**U.S. Department of Energy
Hanford Site**

**RESPONSE TO THE NOTICE OF DEFICIENCY AND THE UPDATED CLOSURE PLAN
FOR TANK TK-P4 AND TANK TK-40 IN SUPPORT OF THE HANFORD FACILITY
DANGEROUS WASTE CLASS 3 PERMIT MODIFICATION REQUEST SUBMITTED
JULY 11, 2016**

Response to the Notice of Deficiency Review Comment Record for
Review of Tanks TK-P4 and TK-40 Closure Plan

Document Title(s)/Number(s): PUREX TK-P4 and TK-40 Class 3 Permit Modification

Figure 2. Tanks TK-P4 and TK-40

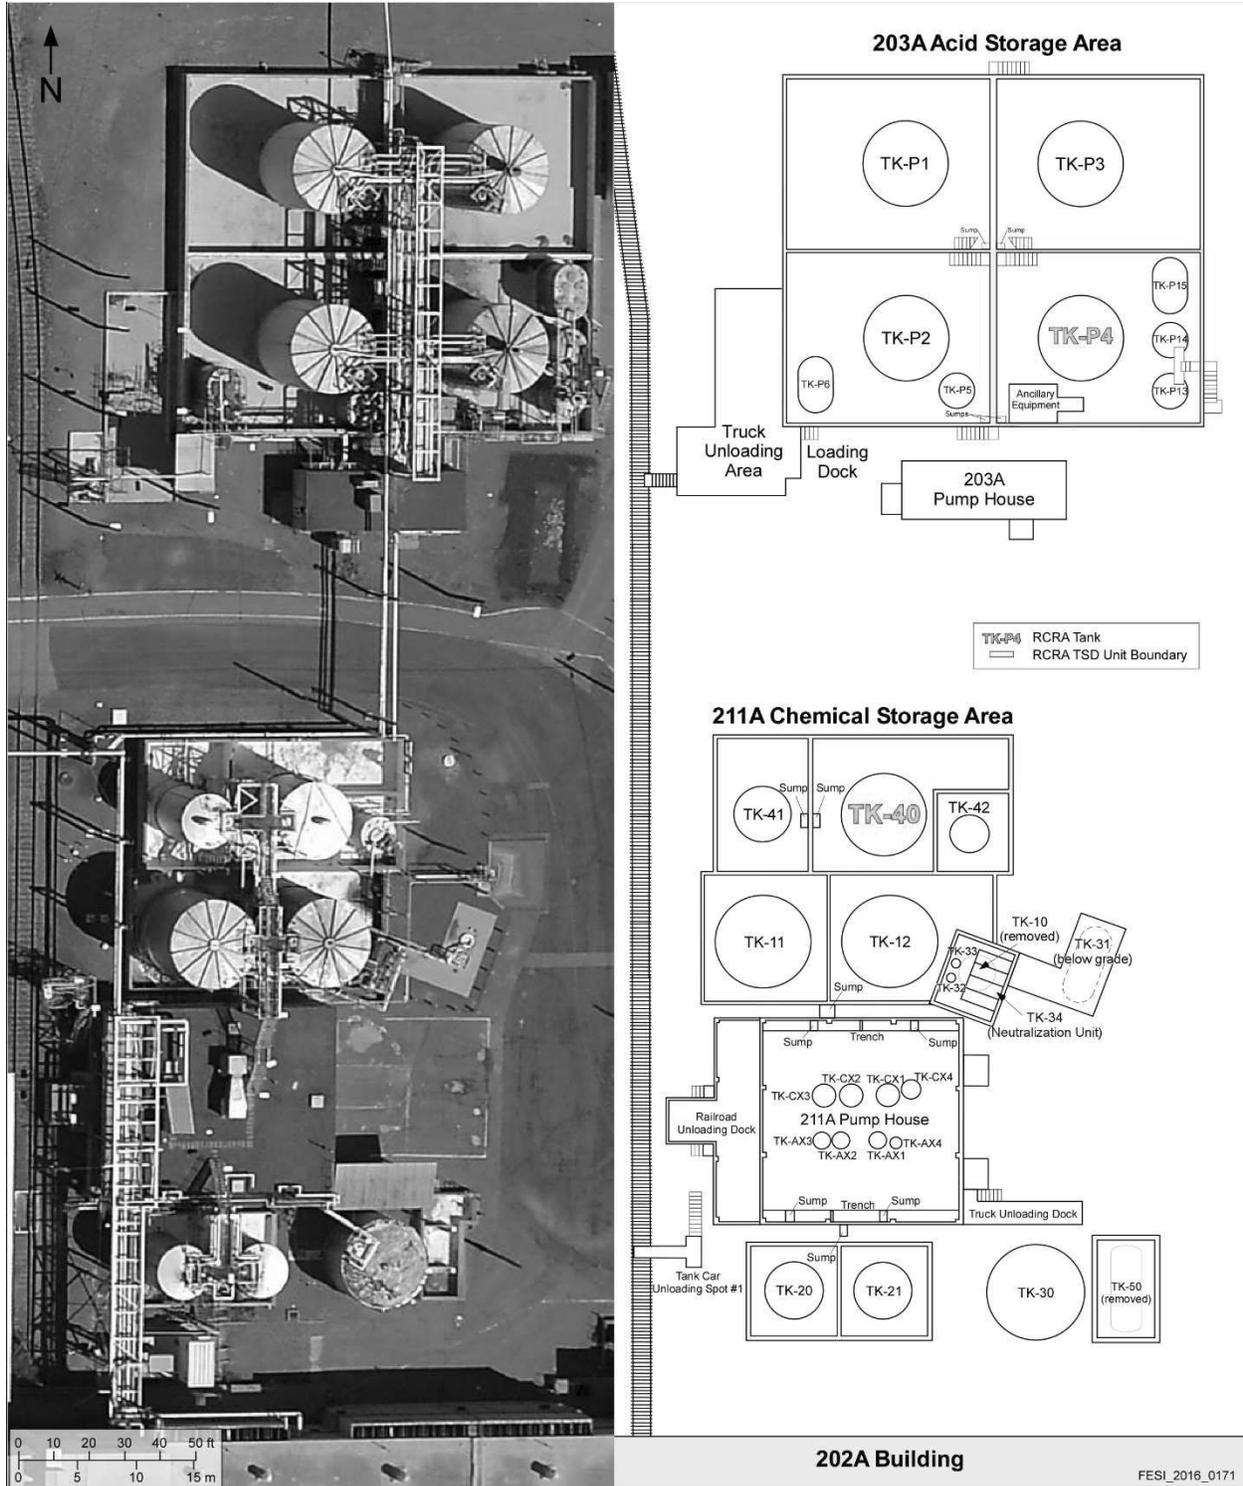
Review Comment Record		Washington State Department of Ecology Nuclear Waste Program				Date: 10/8/2019	Open/Close	Reviewer Initials
Item No.	Pg. # Sec. # Para./Sent.	Comment or Question	Modification Needed	Basis/Justification	Permittee Response	Ecology Response	Open/Close	Reviewer Initials
16	Pg. 3, Sec. 1.1.2	The photograph for TK-40 is not clearly distinguishable.	Provide labeling of TK-40 in the photograph. Ecology suggests that DOE replace the photograph of TK-40 with the photograph provided in the locked down PUREX Rev 9 Part A form that Ecology and DOE agreed to in 2019.		Figures 2 and 3 have been replaced with a new figure that shows a photo and schematic of TK-P4 and TK-40 within the 203A and 211A areas.	Accept	Close	
17	Pg. 3, Sec. 1.1.2	The diagram for TK-40 should include a scale and a compass rose.	See comment.		A scale and a north arrow have been added to Figure 2.	Accept	Close
